#### APPEAL SUMMARY

Appeal ID: 16553	Project Address: 1900 SE Lafayette St
Hearing Date: 2/28/18	Appellant Name: Mike Moerlins
Case No.: M-007	Appellant Phone: 503-382-2643
Appeal Type: Mechanical	Plans Examiner/Inspector: Thomas Ng
Project Type: commercial	Stories: 2 Occupancy: Utility and Misc Group U Construction Type: Type I
Building/Business Name:	Fire Sprinklers: Yes - Hoistway
Appeal Involves: Alteration of an existing structure	<b>LUR or Permit Application No.:</b> Original Building Permit #: 14-127672-000-00-CO
Plan Submitted Option: pdf [File 1]	Proposed use: Elevator

LAFAYETTE ELEVATOR CORRECTIVE ACTION PLAN

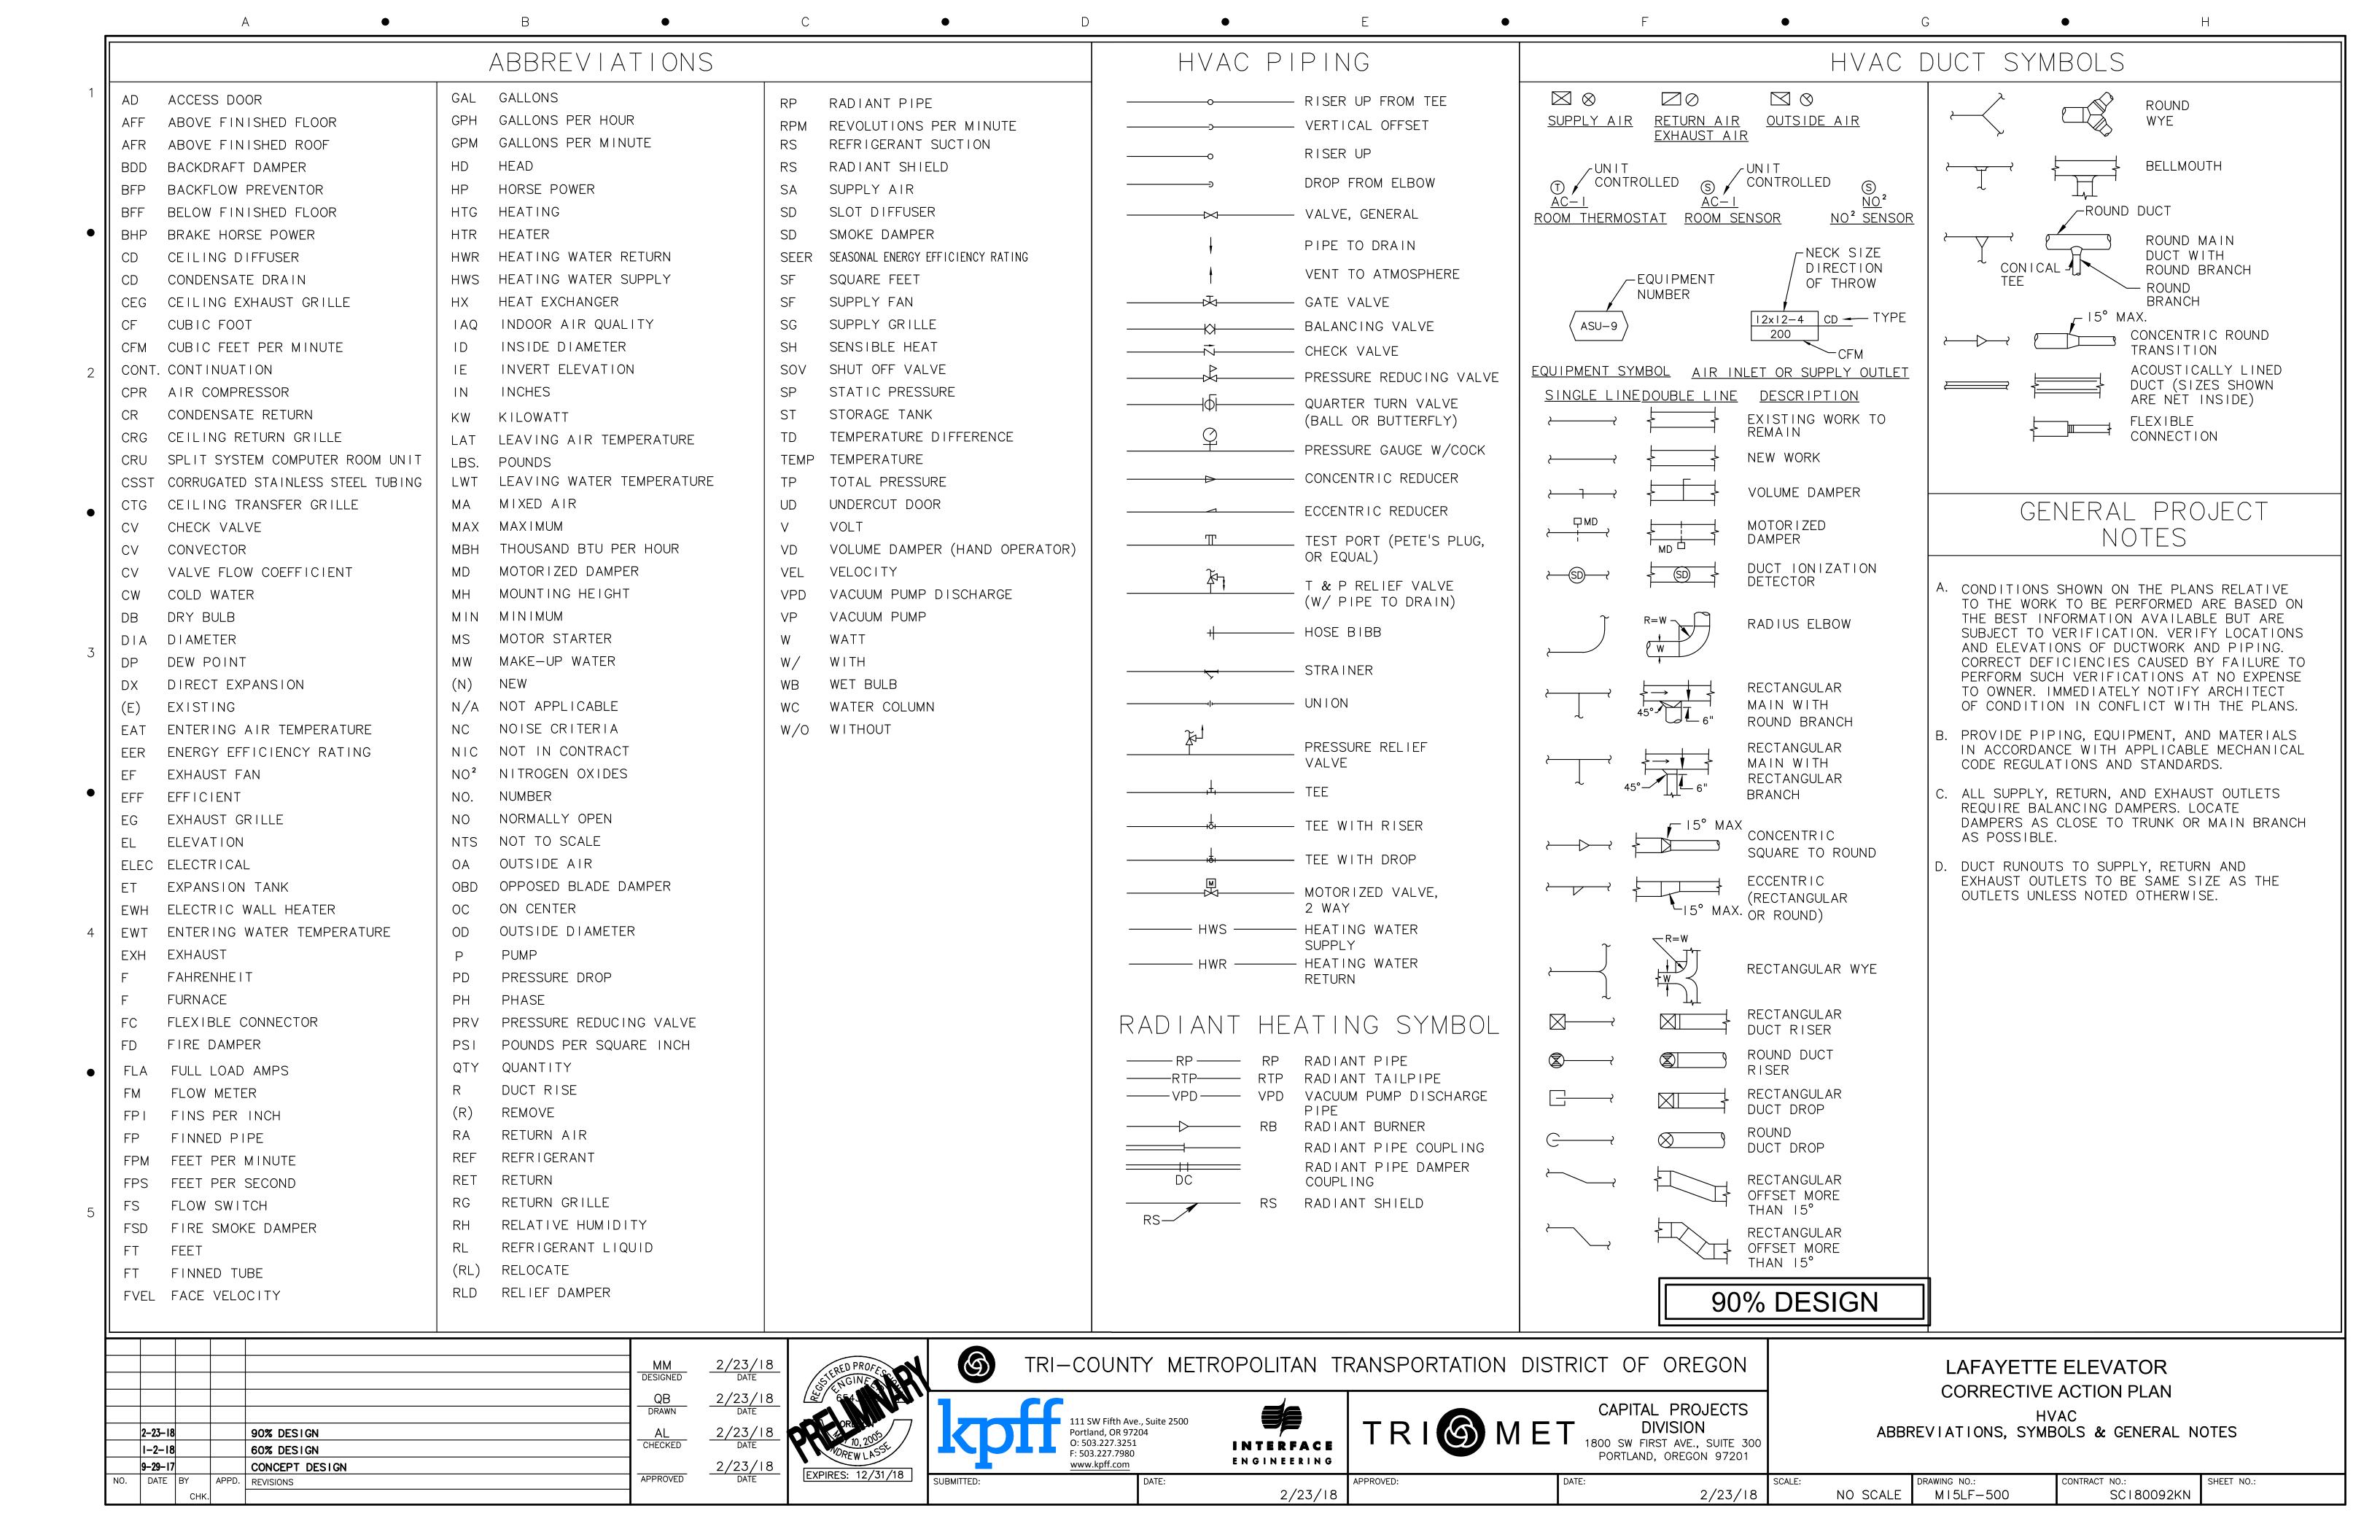
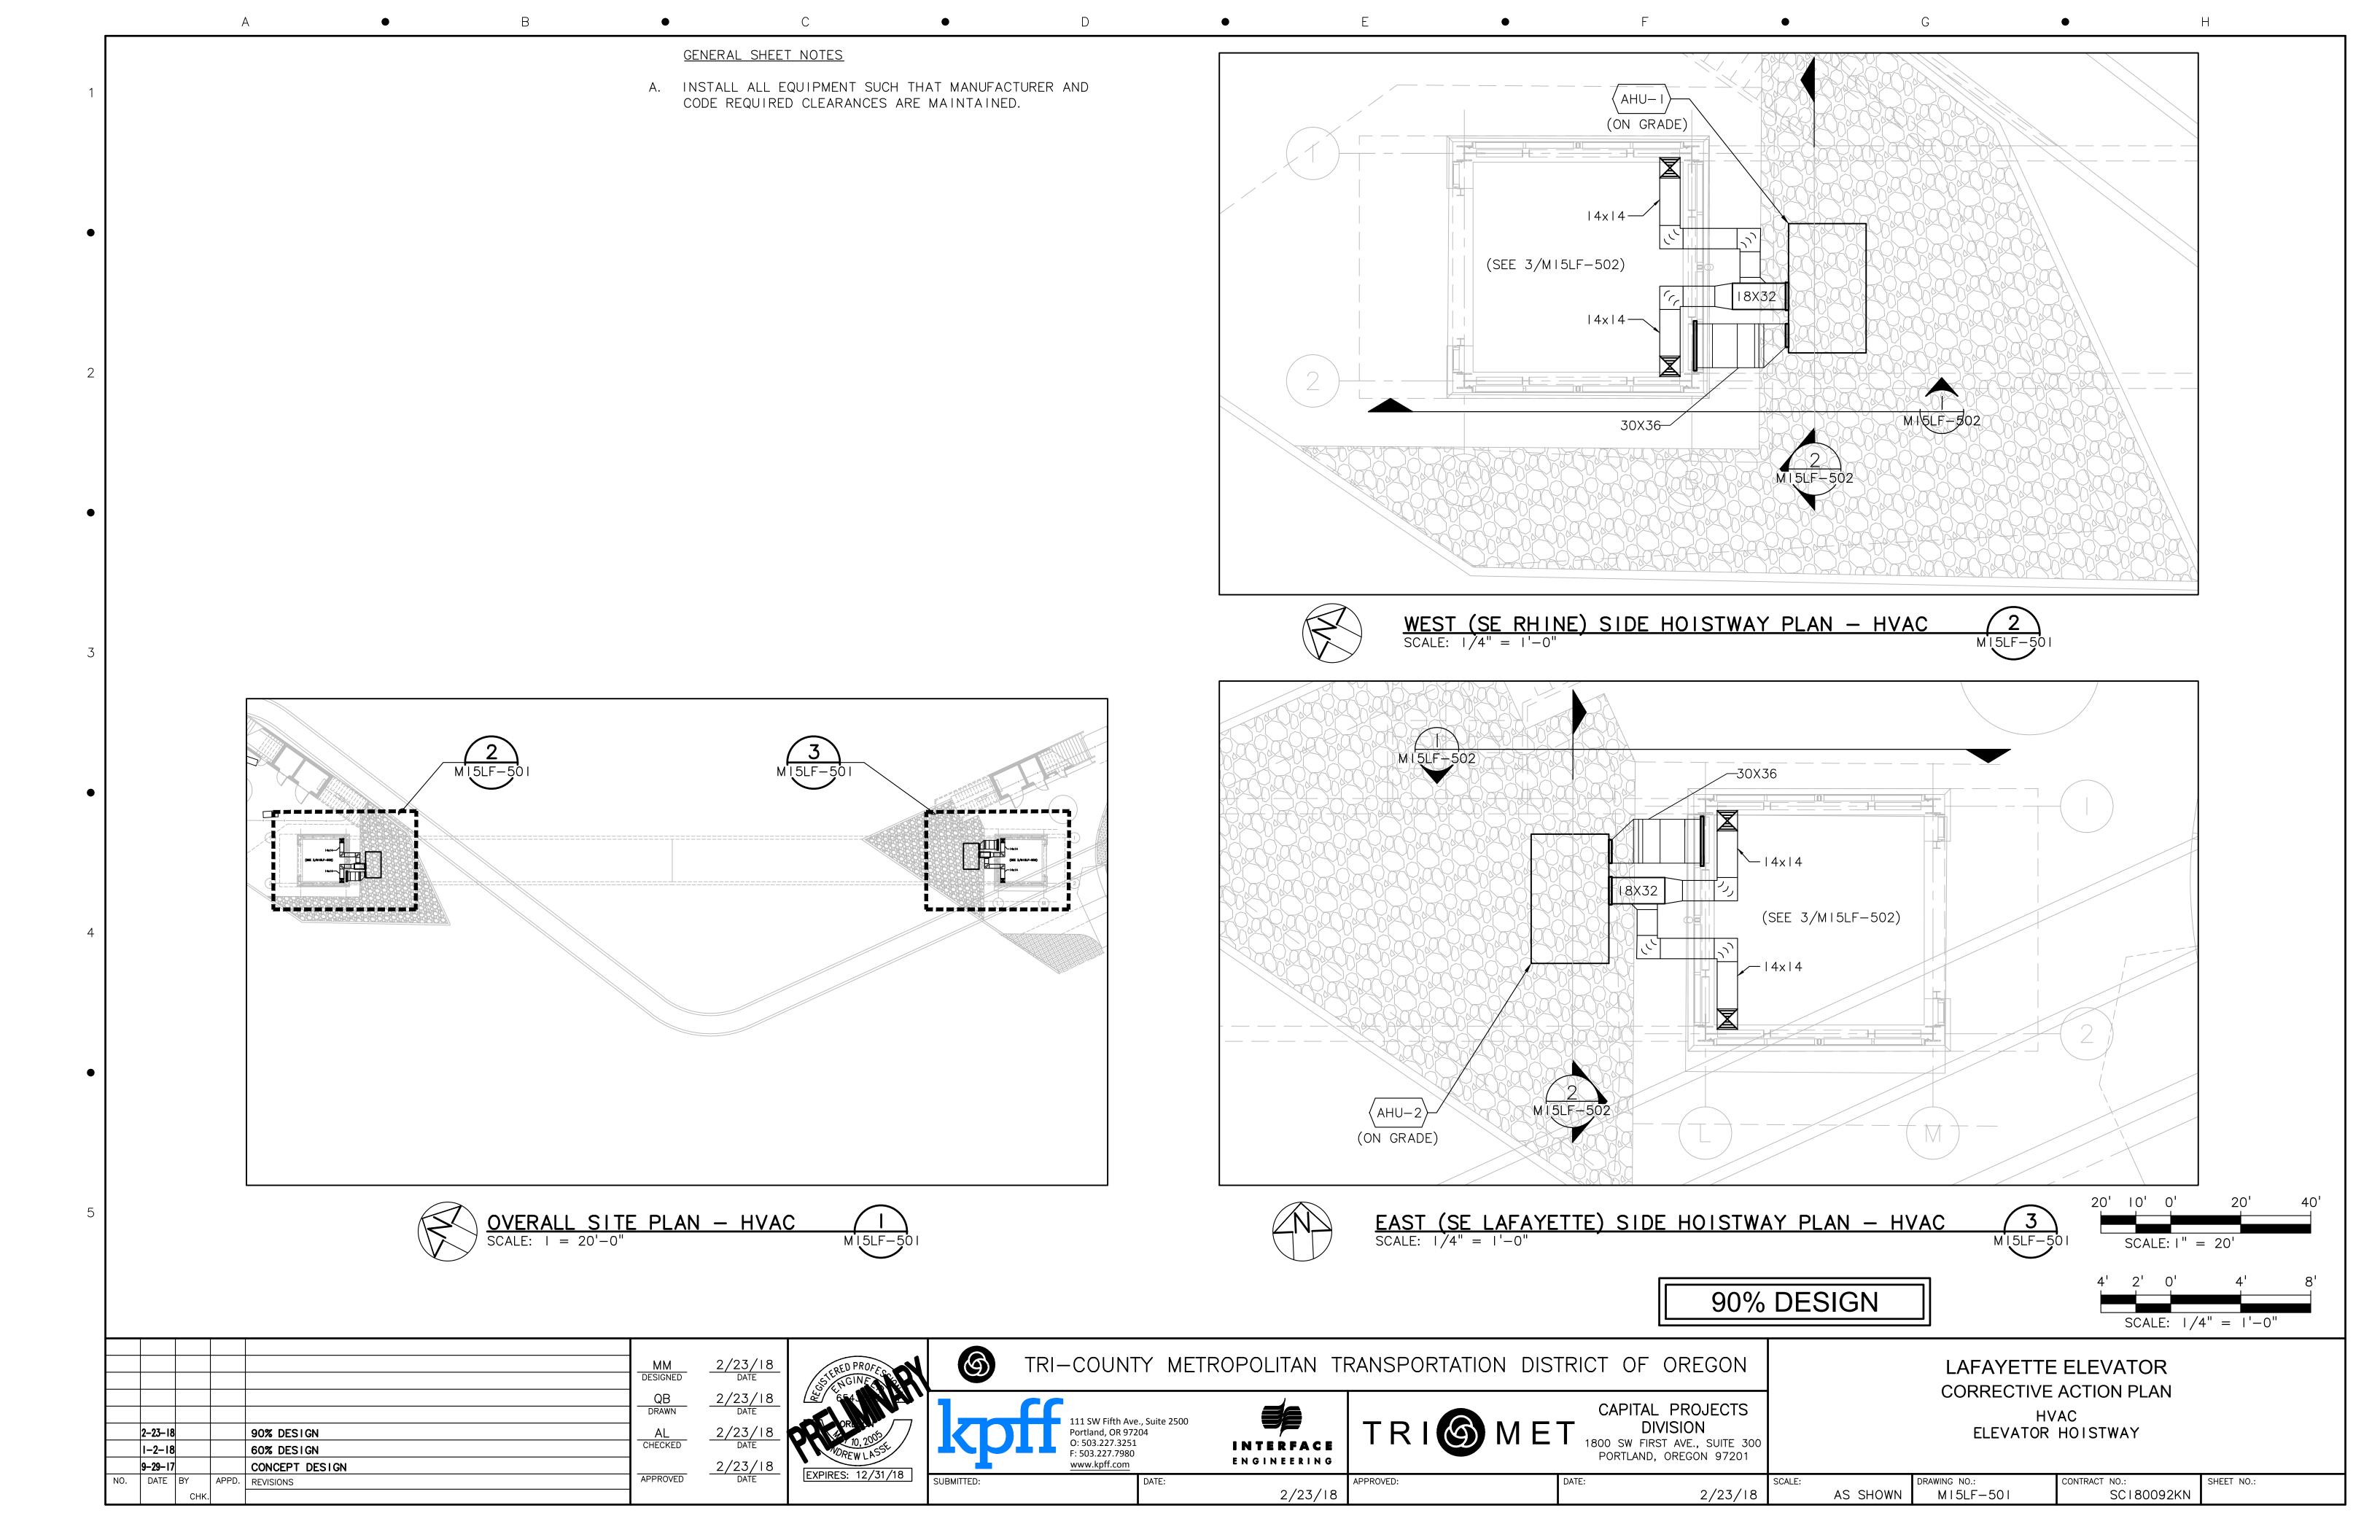
#### **Proposed Design** This project includes the addition of a packaged HVAC system to serve an existing glass and steel

elevator hoistway, to provide heating and cooling only as required to meet the temperature and humidity requirements of the elevator machinery, for safe operation of the elevator system.

The proposed design does not include upgrades to the hoistway envelope (opaque assembly insulation, fenestration, etc.).

#### Reason for alternative Because this HVAC equipment is being installed only to serve the elevator equipment, and the

hoistway itself is an unoccupied "small building" (around 220 square feet) per OEESC 101.5.3, we believe that the energy code upgrades to the envelope (which is essentially all glass on four sides and an uninsulated roof) would not be required, even with the addition of HVAC to the space.

Additionally, the elevator hoistway walls are primarily glass due to visibility and safety concerns, and it's operation is needed to provide ADA access to the bridge. Our interpretation of the energy code is that it is not intended to abridge safety requirements per OEESC 101.3, which would potentially occur with the addition of opaque insulation to the hoistway envelope.

Omission of envelope insulation in elevator hoistway: Hold for additional information. Appellant may contact Thomas Ng (503-823-7434) for details.
